Contract No. T201007203.01 Federal Aid Project No. EBROS-2010(3) PIPE REPLACEMENTS, KENT COUNTY Kent County

Enclosed is Addendum No. 2 for the referenced contract consisting of the following:

PIPE REPLACEMENTS, **KENT COUNTY**

CONSTRUCTION PLAN

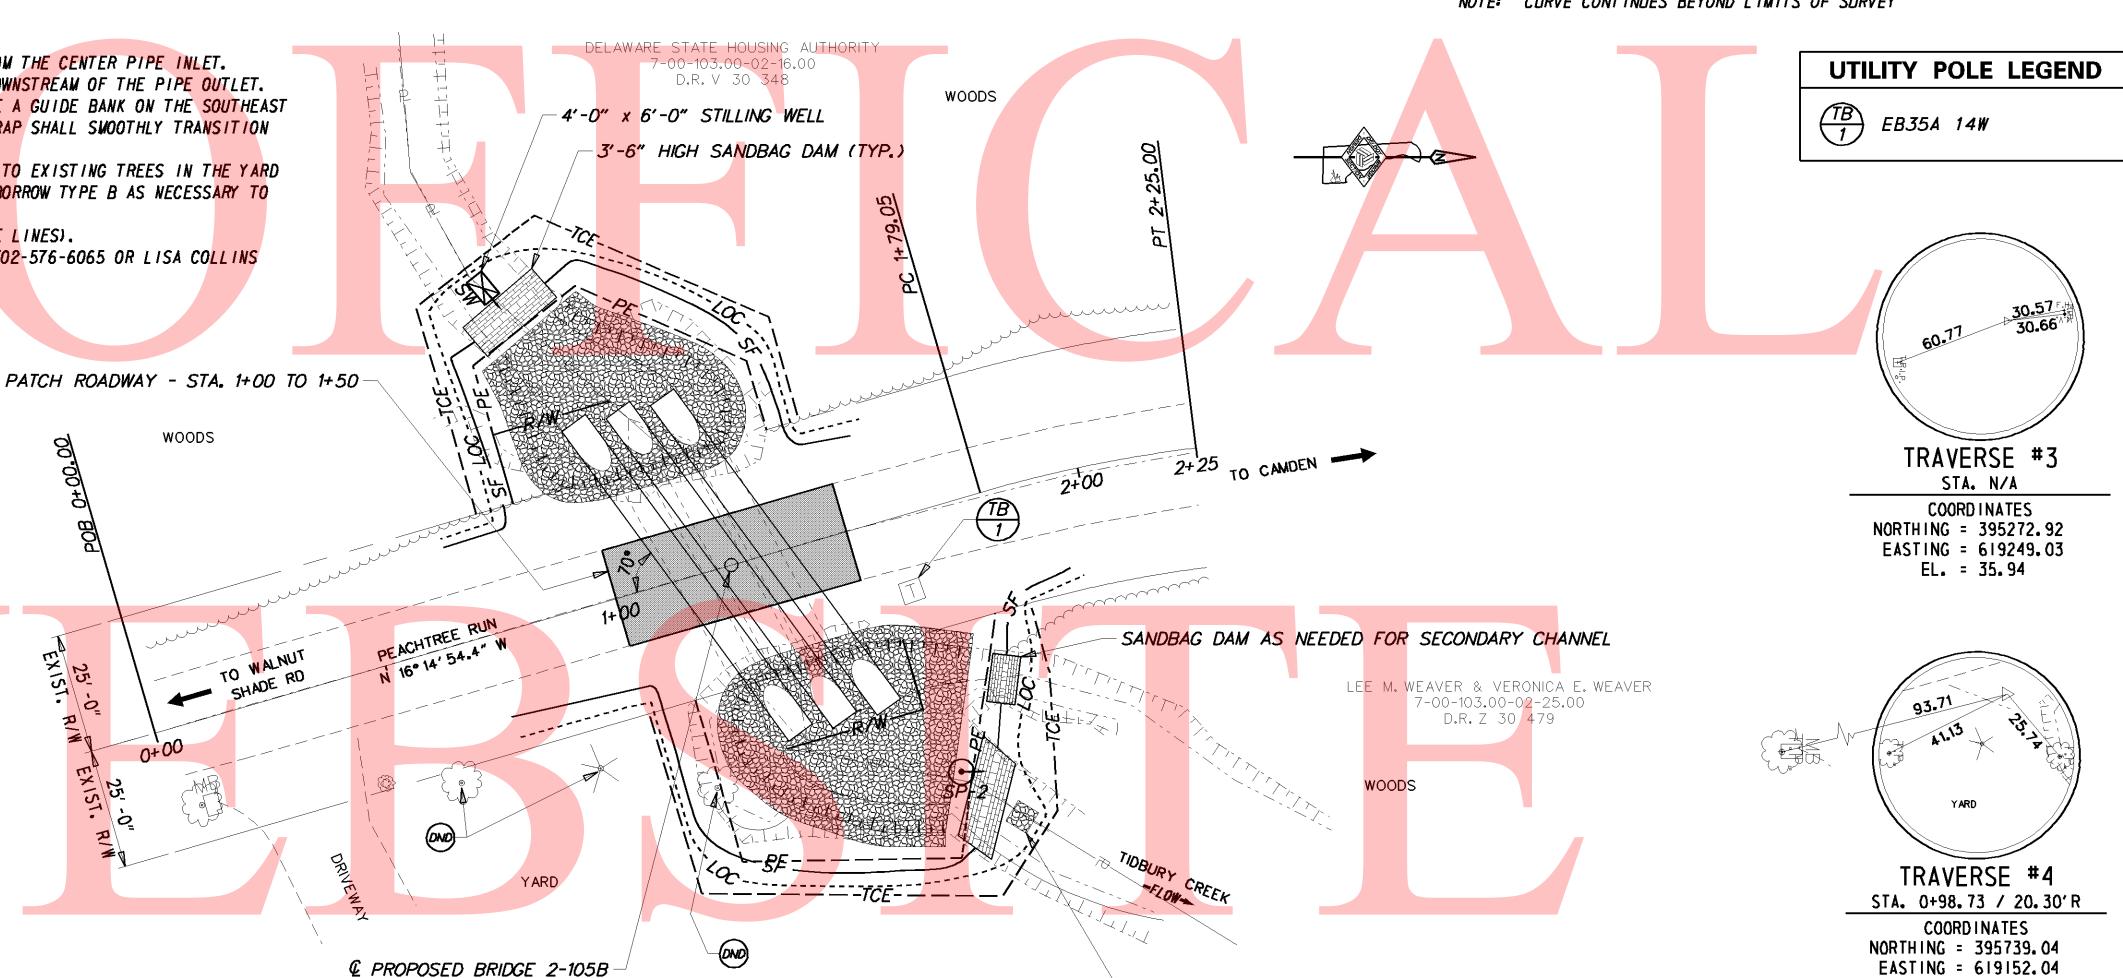
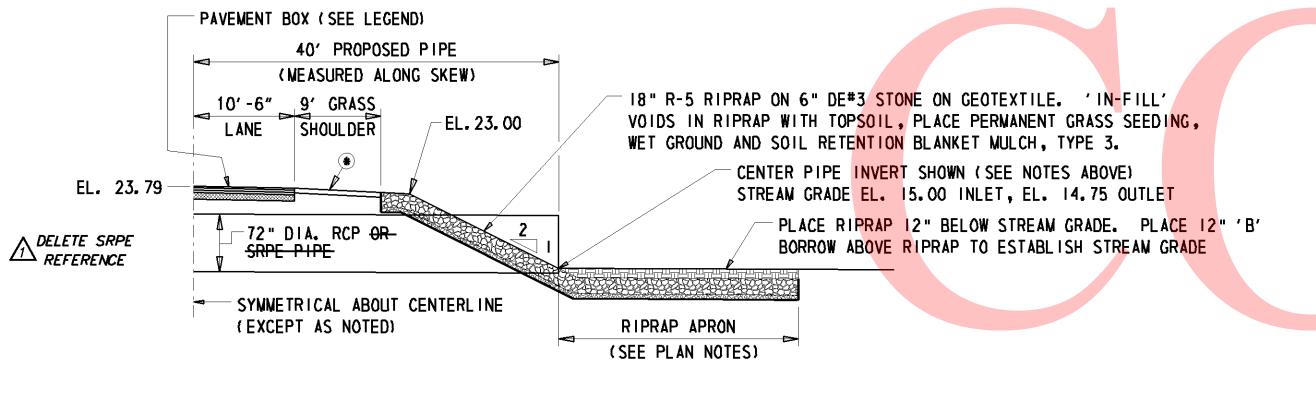
THE EXISTING 3 - 72" DIA. CORRUGATED METAL PIPES SHALL BE REPLACED WITH 3 - 72" DIA. REINFORCED CONCRETE PIPES (80' LONG). THE CENTER PIPE SHALL BE PLACED 6" BELOW THE ESTABLISHED STREAM GRADE. THE INVERT OF THE OUTER PIPES SHALL BE PLACED AT STREAM GRADE TO MAINTAIN ADEQUATE COVER. PLACE PIPES WITH A MINIMUM 3'-O" GAP BETWEEN RUNS. PLACE 6" COARSE AGGRGATE BEDDING BENEATH PIPES. 3 - 72" SRPE (STEEL REINFORCED POLYETHELENE) PIPES WAY /1\DELETE NOTE

ADDENDUMS / REVISIONS **DELAWARE** SCALE /1\ DELETE REFERENCES TO SRPE PIPE **DEPARTMENT OF TRANSPORTATION** FEET
